RE: CHANNEL 9 – RESPONSE TO AJC REVIEW

Please find below an outline of responses to the AJC Summary of Concerns.

2.1 LEVEL CHANGES AND RELATIONSHIP TO THE PUBLIC DOMAIN

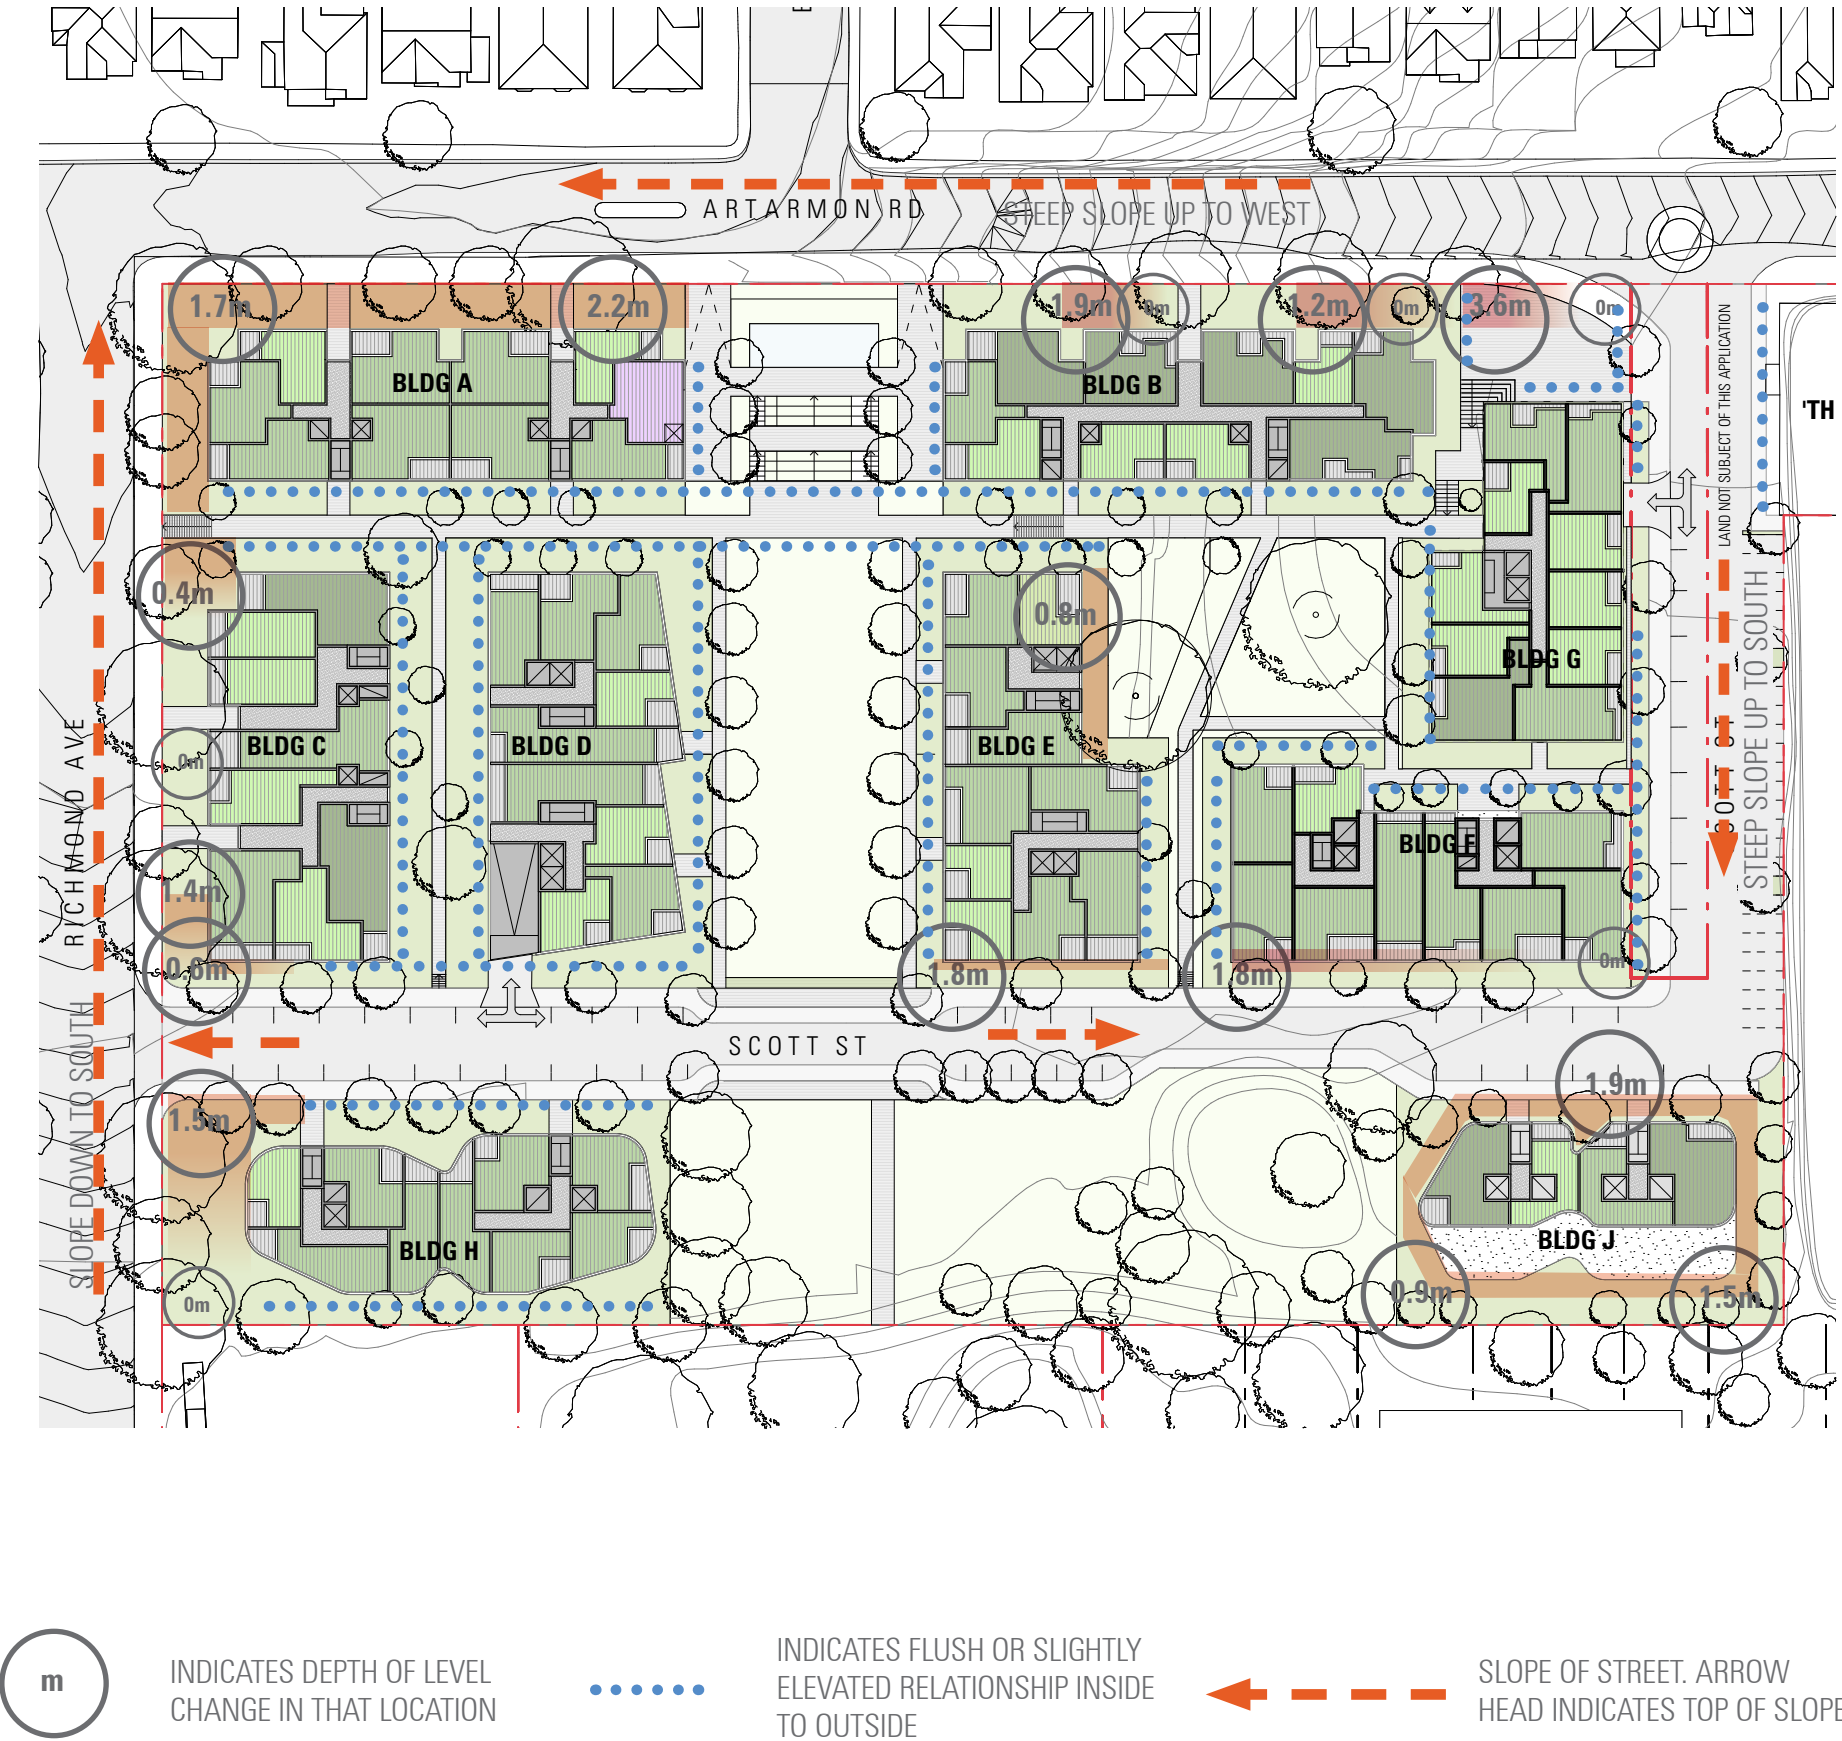
2. Basement apartments will negatively affect street quality, particularly where sunken courtyards directly abut property boundaries.	We understand the concern with courtyard apartments however do not agree they will adversely affect the street quality. Overlooking a fence can occur with flush or courtyard apartments. We agree that keeping fences low at a maximum of 1.2m high is important for the streetscape character. In dealing with the steep slopes of Artarmon Road, we feel there is merit in having courtyard apartments rather than blank facades above street level. However to address the concern we have reviewed the massing and site levels to remove the deepest apartments which occurred in Buildings A, B and C. A plan identifying the amended levels at the street interfaces to Artarmon Road and Richmond Avenue is attached to this letter. Now the deepest of these level changes is 2.2m, and most are considerably less. Apartments can also be designed to ensure the living room is located where the lowest level change occurs, and stepping down from the street can be dealt with sensitively to maximise privacy and open space. Whilst we support the approach of courtyard apartments, we would not object to the alternative of raising the building one level to avoid them as suggested by AJ+C, particularly perhaps on Building A and C where the street is not as steep. It is noted that the detailed design of courtyards will be included in future Development Applications and subject to further assessment.

The following plan indicates where any frontage to a building sits below the adjoining land level, which in most cases is adjacent to a street. These spaces have a proposed sunken courtyard for private open space. The maximum depth of these sunken courtyards for any apartment is 2.2m and in most cases is significantly less than this. Typically they diminish to 0 along the steep surrounding streets to the site.

Spaces adjoining tree 32 (retained) are slightly sunken by 0.8m to allow the tree to maintain its natural ground level. Building J is also slightly sunken to help reduce visible mass.

All other frontages (noted in a dotted line) have an internal floor plate that is flush or slightly raised above the adjoining land. This level connection to key communal and public open spaces is critical for quality edges to the public open spaces.
